RESOLUTION NO. ~~10-R31~~ 12-R102

A RESOLUTION OF THE CITY COUNCIL OF THE CITY OF PORT ST. LUCIE, FLORIDA, TO AMEND THE PGA VILLAGE DEVELOPMENT OF REGIONAL IMPACT (DRI) APPROVED BY RESOLUTION 03-R68 ON OCTOBER 27, 2003, INCLUDING THOSE AMENDMENTS APPROVED BY RESOLUTION 03-R96 ON DECEMBER 15, 2003, RESOLUTION 09-R49 ON APRIL 13, 2009, ~~AND~~ RESOLUTION 09-R138 ON OCTOBER 26, 2009, AND RESOLUTION NO. 10-R31 ON JUNE 14, 2010 IN ACCORDANCE WITH THE REQUIREMENTS OF CHAPTER 380, FLORIDA STATUTES; MAKING FINDINGS OF FACT AND CONCLUSIONS OF LAW PERTAINING TO THE VERANO DRI; AND CONSTITUTING THIS RESOLUTION AS THE AMENDED DEVELOPMENT ORDER FOR THE VERANO DRI IN COMPLIANCE WITH LAW; PROVIDING AN EFFECTIVE DATE; AND PROVIDING A TERMINATION DATE.

Re: Verano Development of Regional Impact Notice of Proposed Change
Response to Comments (Dated October 11, 2011; Received September 13, 2012)
Project No. P11-123
MEP Job # 002005

PLANNING AND ZONING COMMENTS

Crosstown Parkway Interchange

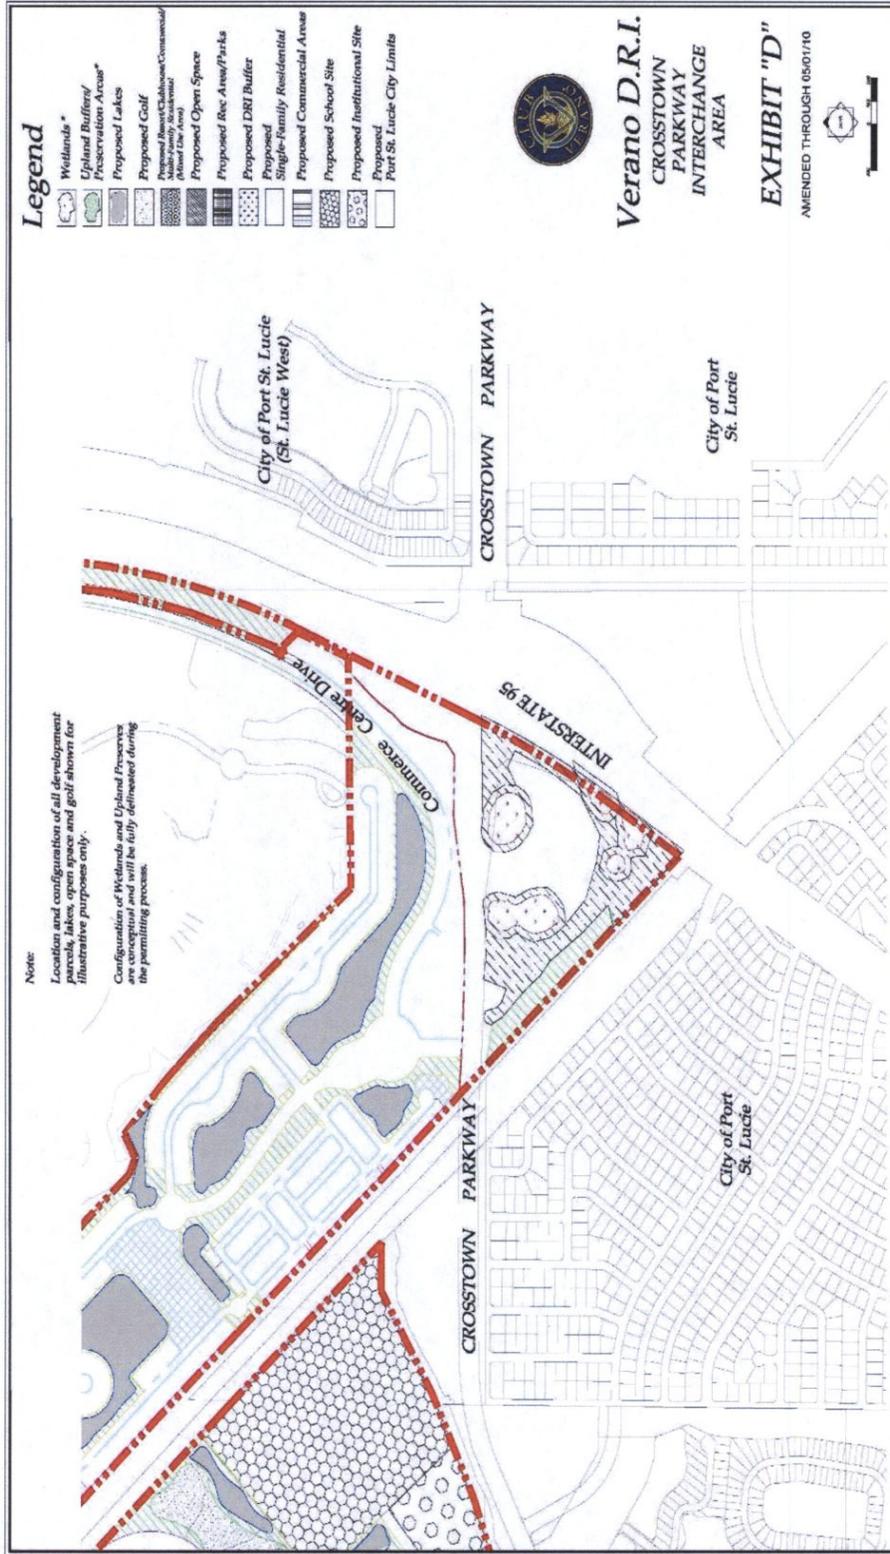
- ~~11. Please explain the changes to the chart, conversion matrix, on page 15.~~
- ~~12. Page 44, which appears to be Map H, does not contain Map H.~~
- ~~13. Exhibit D, page 50, is the Crosstown Parkway Interchange, however the image is not on this page, it has the wording 'go to next page'. The next page (60) is intentionally left blank. Exhibit D is found on page 61; please correct the text on page 50 to correctly identify what page this exhibit is on. There is a similar issue with PGA Village Central MXD Design Criteria, Exhibit E on page 63.~~

*Crosstown Parkway
Access Management Plan*

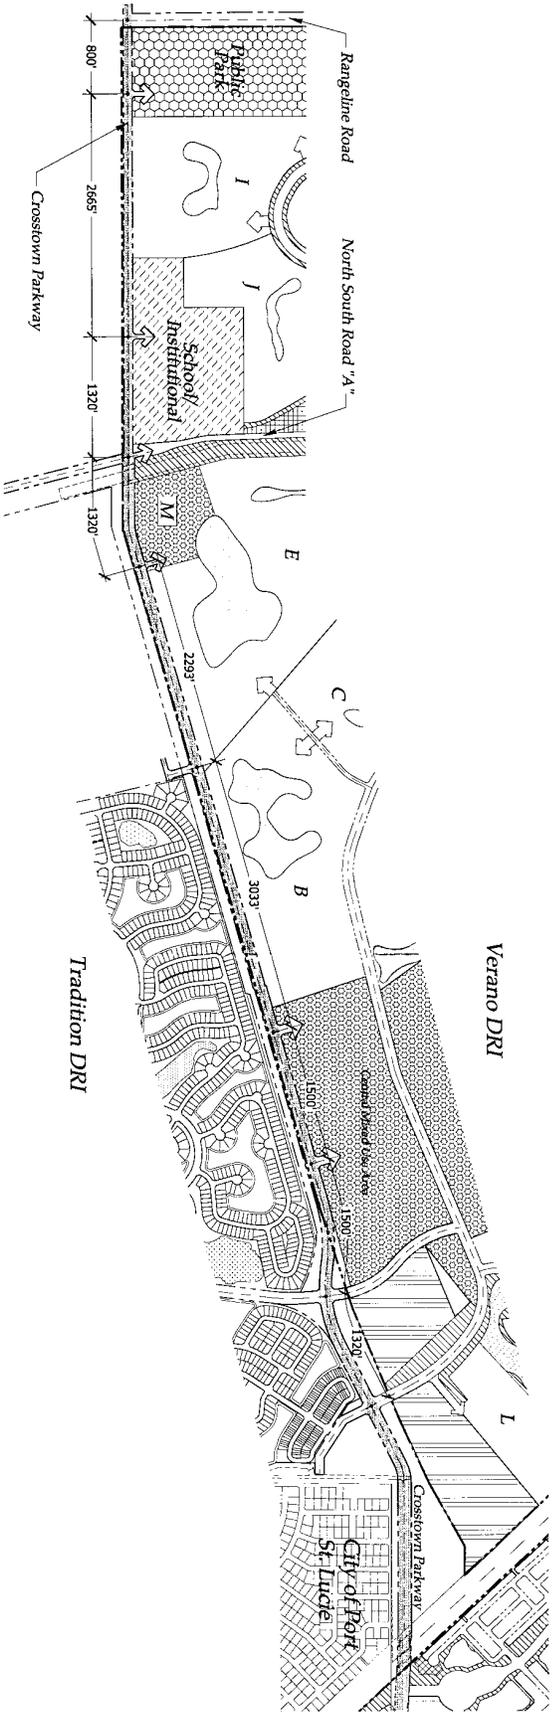
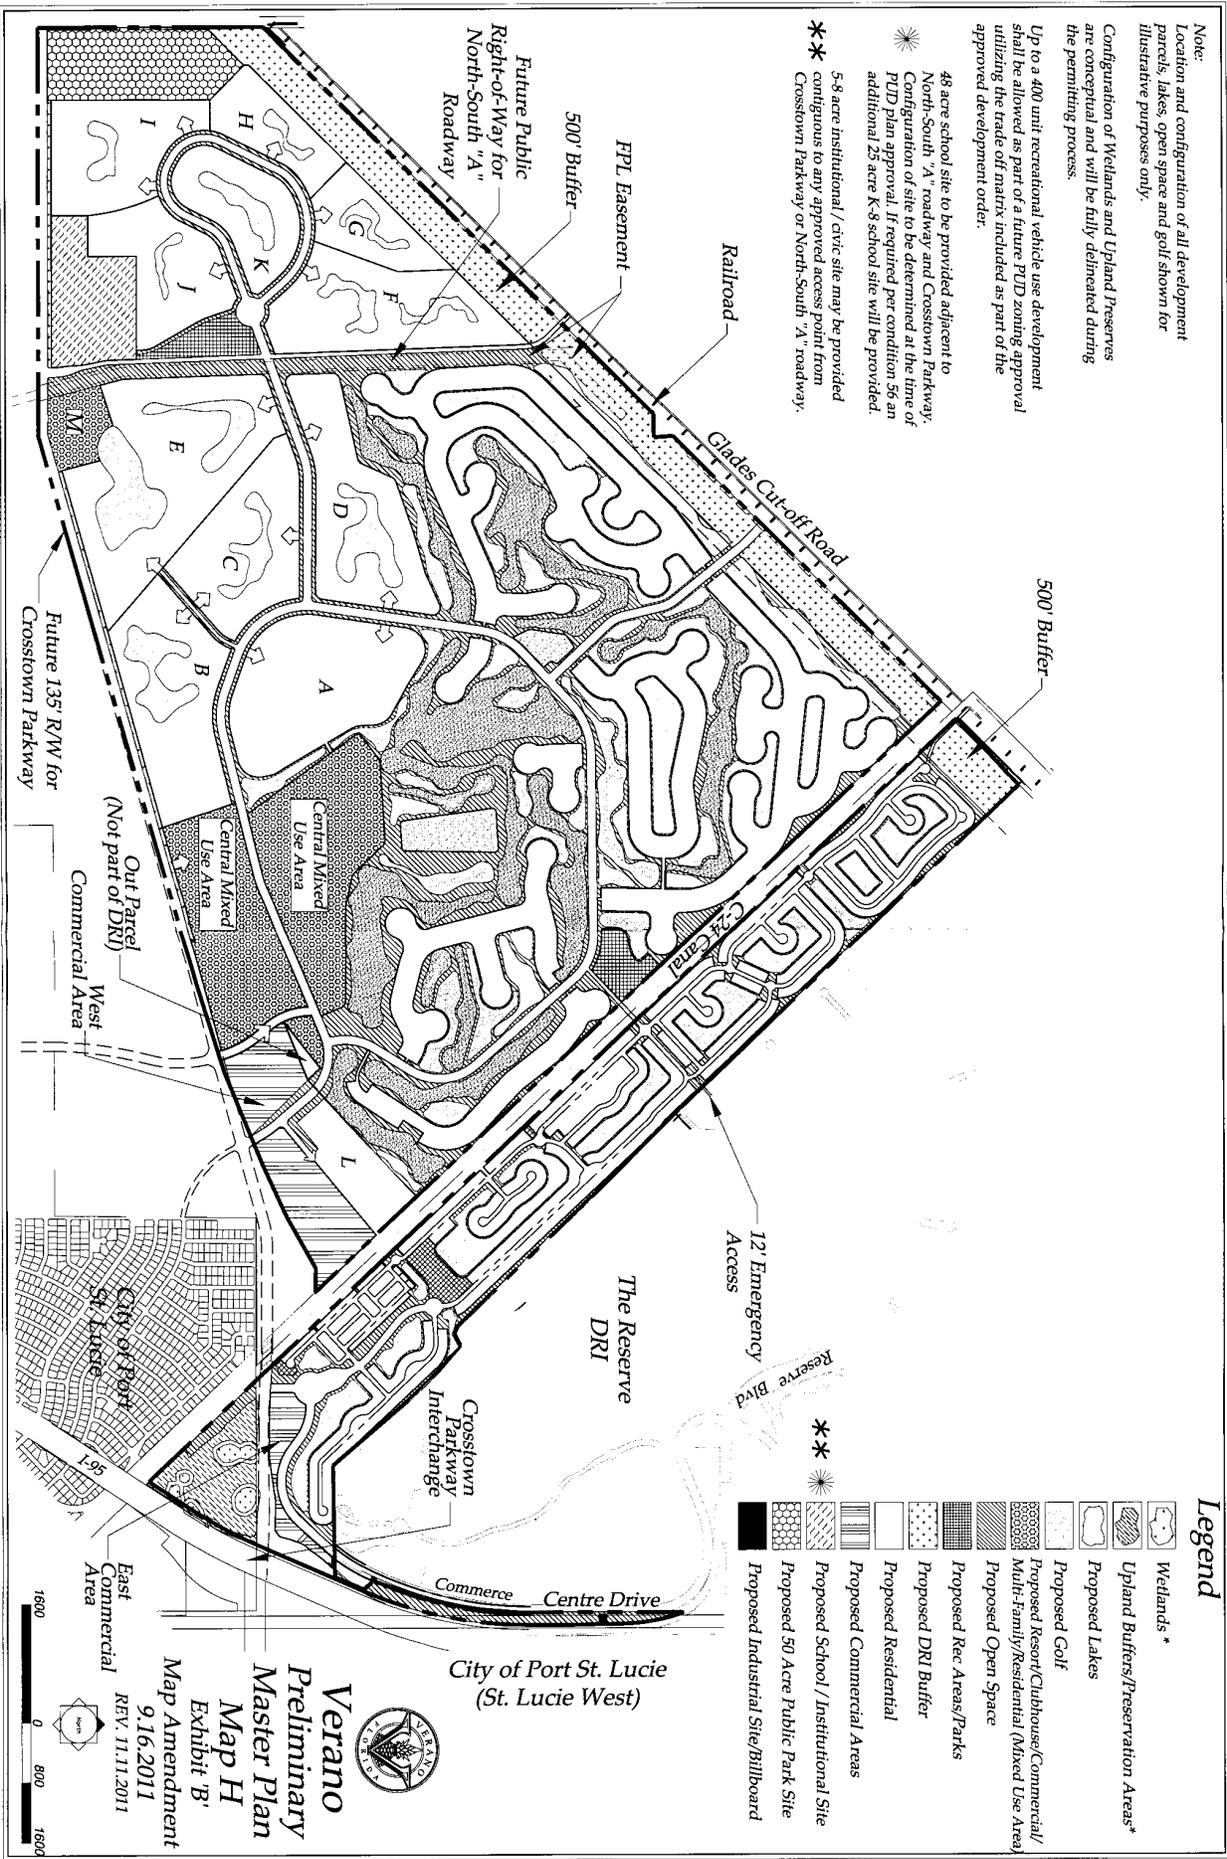
15. Has the Crosstown Parkway Access Management Plan been approved by the City's Engineering Department.

Response: Yes.
